**UNITED STATES ENVIRONMENTAL PROTECTION AGENCY
REGION IX**

June 16, 2011

Re: Aspire Public School, 1009 66th Avenue, Oakland, California – USEPA November 13, 2009 Approval of Polychlorinated Biphenyls' Cleanup Notification Under Toxic Substances Control Act – New Request for Additional Cap Modification

Proposed Toxic Substance Control Act (TSCA) Cap for Pavement Areas –
Former Pacific Electric Motors Facility, 1009 66th Avenue, Oakland, California

PROPOSED PAVEMENT PLAN

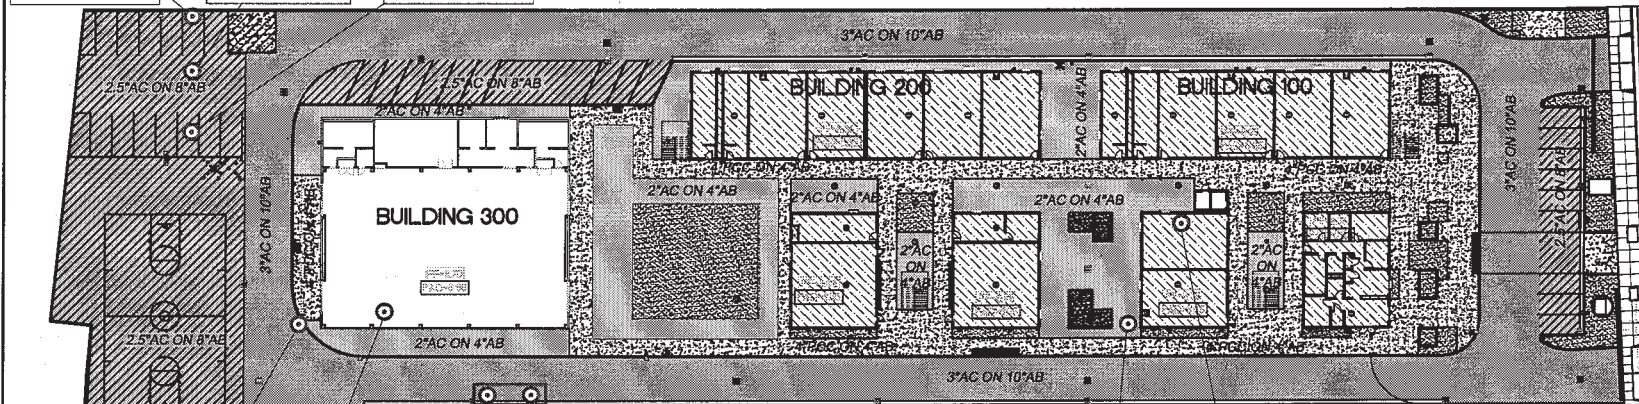
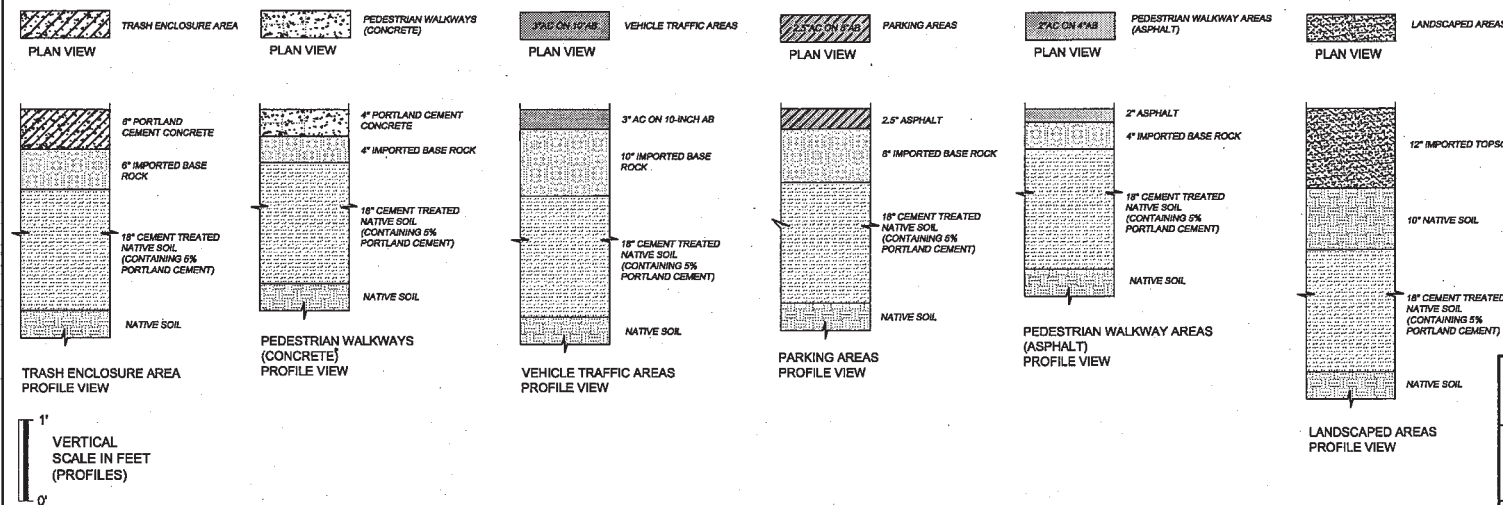
The additional cap modifications proposed in the attached Arcadis' April 25, 2011 letter and described in Figure 2 (Proposed Pavement Plan) of that letter differ from the cap requirements in 40

CFR 761.61(a)(7) and include landscape areas. Figure 2 also describes the soils that will be used to construct the proposed landscape areas; and those areas were not a feature of the original site-wide cap proposed in the October 2009 Notification consistent with the cap requirements in 40 CFR 761.61(a)(7).

We are approving the proposed design for the site-wide cap (excluding the already approved design for the rat slab areas) and landscape areas described in the attached Arcadis' letter under the TSCA regulations in 40 CFR 761.61(c) (risk-based cleanup option) with the conditions established below. This approval modifies the site-wide cap (excluding the rat slabs) required in Condition 8 of USEPA's November 13, 2009 conditional approval letter.

Within 10 days after Arcadis' receipt of the laboratory analytical results for the imported soil samples, please submit the laboratory analysis results to USEPA for review before imported soils are placed in the landscape areas designated in Figure 2 of the attached Arcadis' letter. This data must also be provided to ACDEH.

- 2. Proposed Landscape Areas.** As described in the attached Arcadis' letter, the proposed landscape areas will consist of an 18-inch layer of cement-treated site soils (bottom layer), a 10-inch soil layer (middle layer) from soils excavated at the site during trenching, and a 12-inch layer (top layer) of imported soils. According to Arcadis, the bottom soil layer contains PCBs at concentrations below the site-specific cleanup level of 0.13 total PCBs as Aroclors. The 10-inch native soil layer proposed to be added above the 18-inch cement-treated soil layer must be replaced with imported soils that have been tested as required in Condition 1 above. This requirement is based on the fact that soils derived from trench excavations at the site that have not been tested for PCBs and other non-PCB contaminants are proposed for use in the 10-inch soil layer for the landscape areas. Edible plants, fruits, and vegetables should not be planted in the proposed landscape areas.

- 1. Imported Soil for Use at the Aspire Site.** Within 15 days after the date of this approval, please submit a summary of the sampling approach that Arcadis will use to collect samples of imported soils planned to be used at the Aspire site in the landscape areas and possibly at other areas of the site. This summary should also be submitted to the Alameda County Department of Environmental Health (ACDEH). The California Department of Toxic Substances Control (DTSC) "*Information Advisory Clean Imported Fill Material*," dated October 2001 or latest revision should be used as guidance in developing the required summary. PCBs in the imported soil must be below the site cleanup level of 0.13 mg/kg total PCBs as Aroclors. The levels of non-PCB contaminants must be below the criteria referenced in the Advisory as modified by recent criteria updates. Discrete soil samples must be collected instead of composite samples.
